ADDENDUM NO. 1 TO ITB # 17-0074-4

FOR: MEMORIAL STADIUM

ADDENDUM NO. 1

August 29, 2017

Drawing No: **A-301**

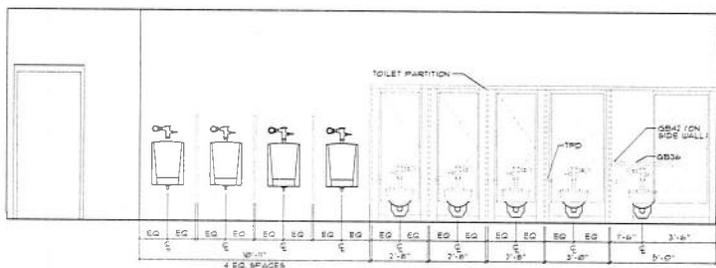
7. Drawing A-301: Revise drawing to include four (4) electric hand dryers in the team toilet rooms according to supplemental drawing A-301_Rev 01 issued with this addendum.

Drawing No. **A-701**

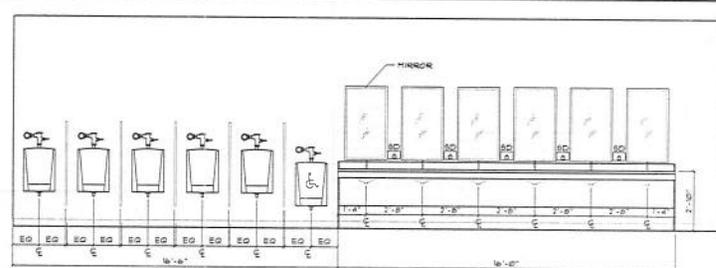
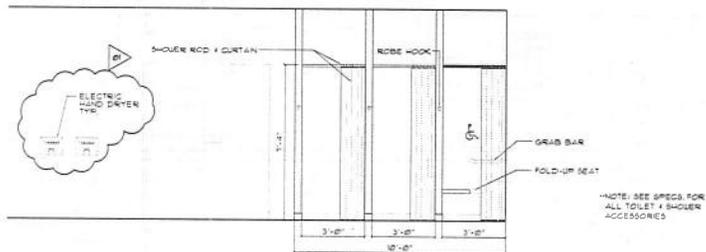
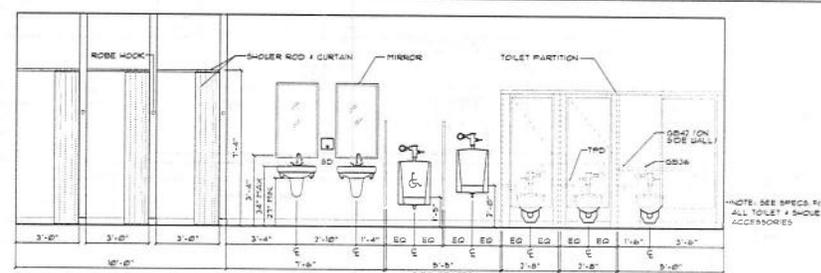
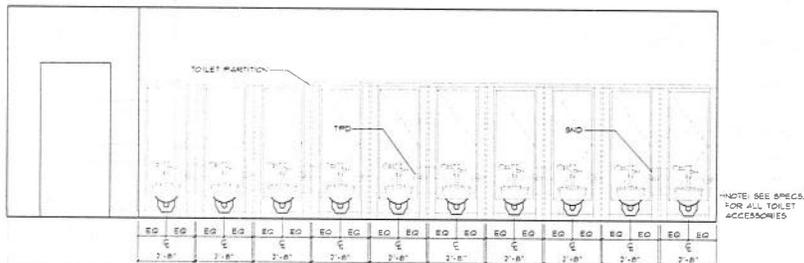
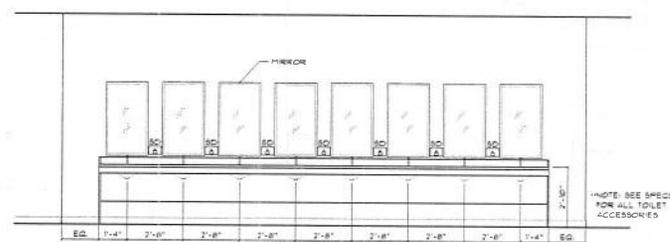
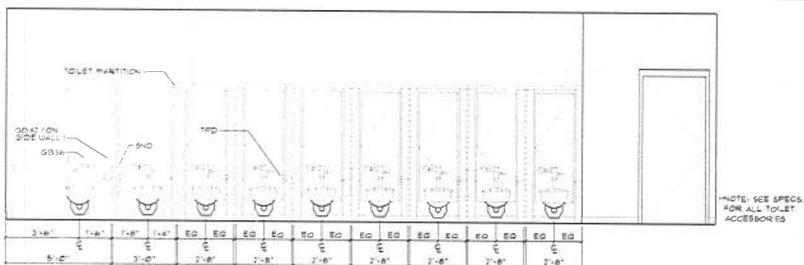
8. Drawing A-701: Revise drawing to include four (4) electric hand dryers in the team toilet rooms according to supplemental drawing A-701_Rev 01 issued with this addendum.

E1.1

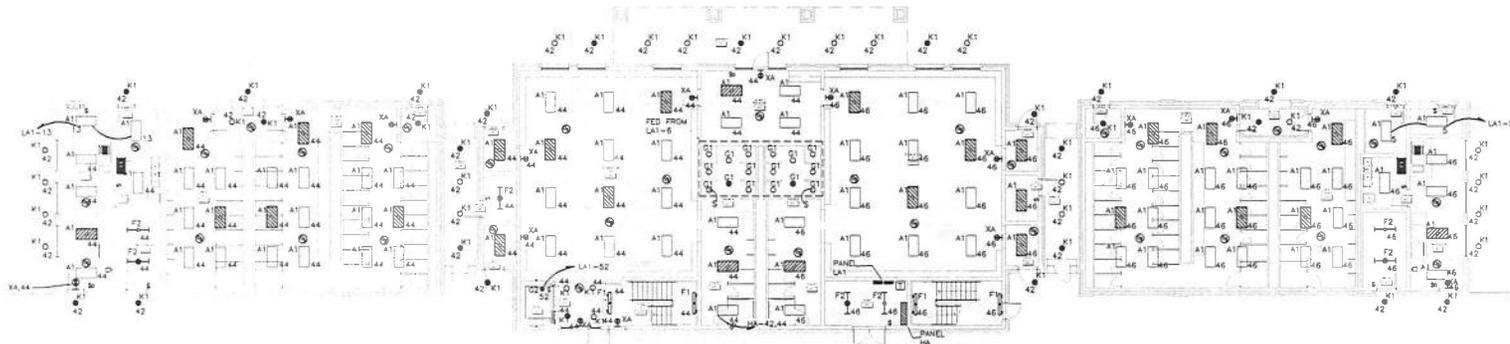
9. Drawing E1.1: Revise drawing to include Area of Refuge Lights in Second Floor Lighting Plan according to supplemental drawing E1.1_Rev 01 issued with this addendum.

ENDZONE BUILDING POWER PLAN

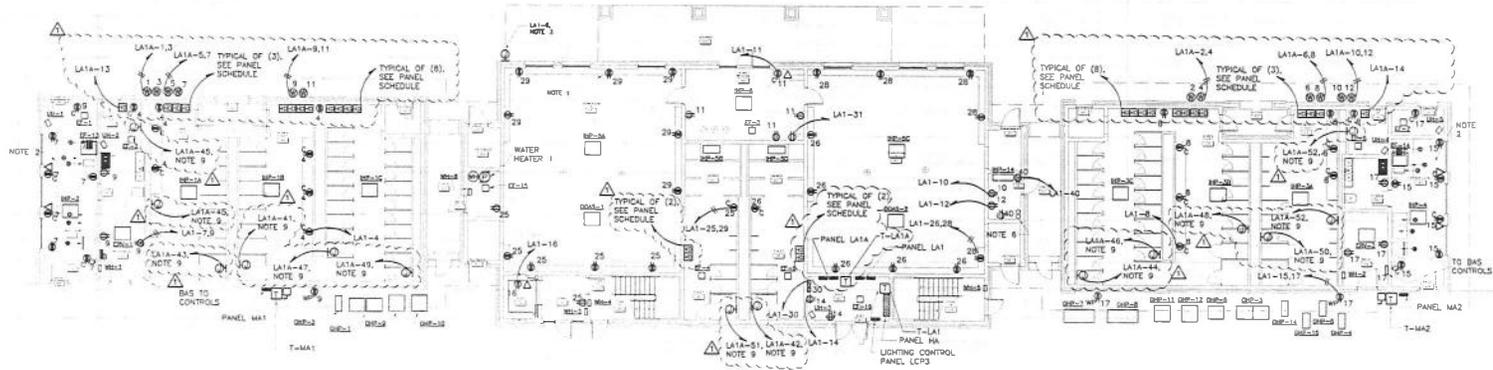
10. Drawing E2.1: Revise drawing to include power for electric hand dryers according to supplemental drawing E2.1_Rev 01 issued with this addendum.
11. Drawing E3.1: Revise drawing according to supplemental drawing E3.1_Rev 01 issued with this addendum.

Drawing No:
T1.1

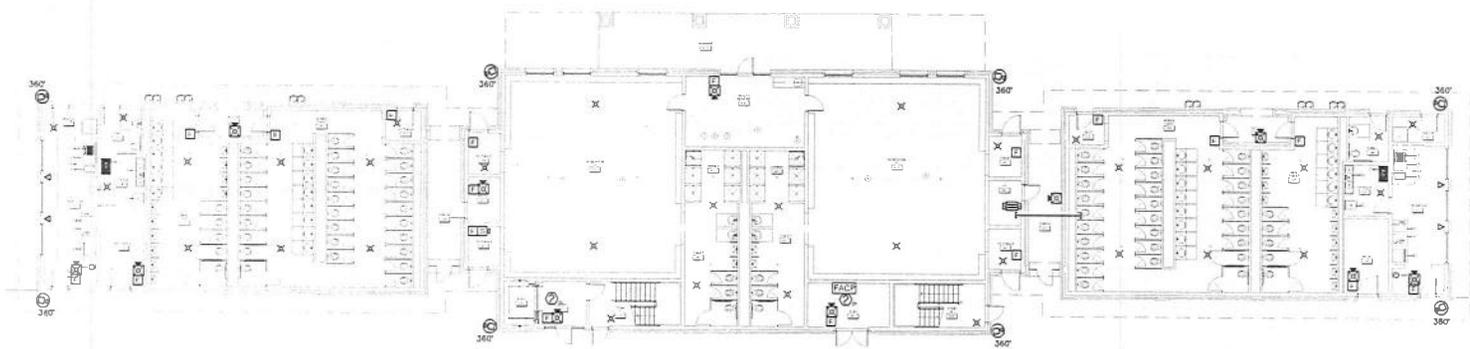
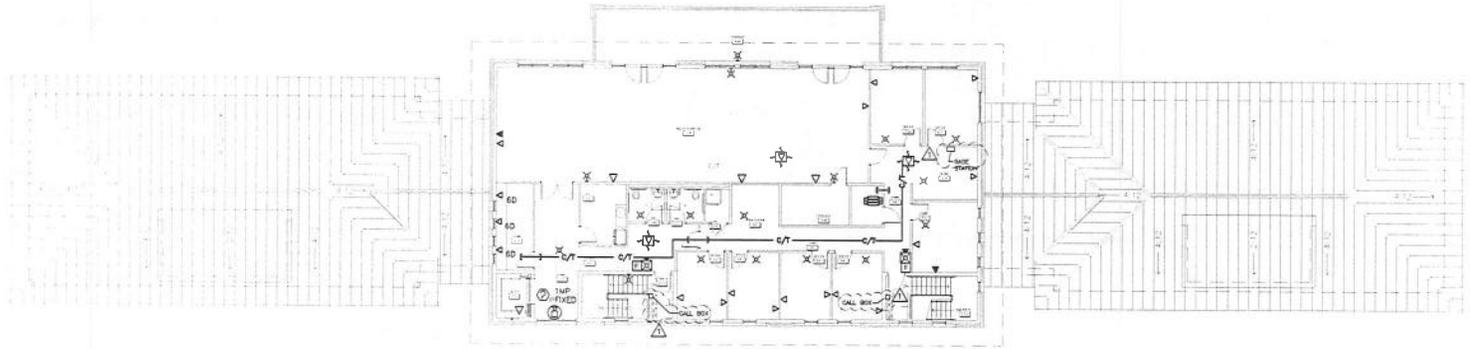
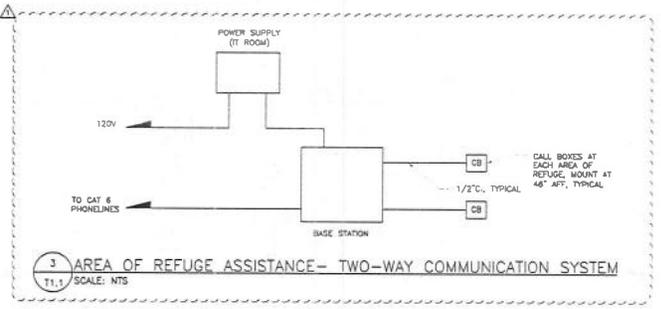
14. Drawing T1.1: Revise drawing to include Area of Refuge call system according to supplemental drawing T1.1_Rev 01 issued with this addendum.

- NOTES:**
1. PROVIDE COMPLETE AREA OF REFUGE CALL SYSTEM WITH ALL EQUIPMENT AND CABLING FOR COMPLETE AND OPERATIONAL SYSTEM.
 2. ONCE THE CALL BOX HAS BEEN PUSHED, THE CALL BOX SHALL CALL THE BASE STATION. IF NO ANSWER AT THE BASE STATION, IT WILL AUTOMATICALLY CALL PROGRAMMED EMERGENCY NUMBERS. CALL BOX SHALL HAVE LOCATION MESSAGING. CALL BOX SHALL HAVE A MINIMUM 18 SECOND RECORDABLE MESSAGE, PROGRAMMABLE TO RUN 2 TIMES. CALL BOX SHALL NOTIFY CALLED PARTY OF THE LOCATION OF THE CALL UPON BEING RECEIVED AT THE EMERGENCY DISPATCH CENTER. CALL BOX SHALL BE CAPABLE OF ALLOWING THE CALLED PARTY TO REPLAY THE LOCATION MESSAGE, IF NECESSARY TO ENSURE AN UNDERSTANDING OF THE CALLER LOCATION. IF SYSTEM IS NOT ATTENDED THE CALL BOX SHALL DIAL A SECONDARY LOCATION OUTSIDE THE BUILDING TO ACTIVATE THIS WAY OFF-SITE PERSON TO PERSON VOICE COMMUNICATIONS ONCE A CALL HAS BEEN MADE (BUTTON PUSHED). THE CALL CAN ONLY BE TERMINATED BY THE CALLED PARTY. CALL BOX SHALL HAVE A BLUE LED THAT ILLUMINATE UPON ACTIVATION OF THE BUTTON. THE LIGHT SHALL BE A SOLID COLOR WHEN THE CALL BOX IS ACTIVATED, AND WILL FLASH WHEN CALL HAS BEEN ANSWERED.
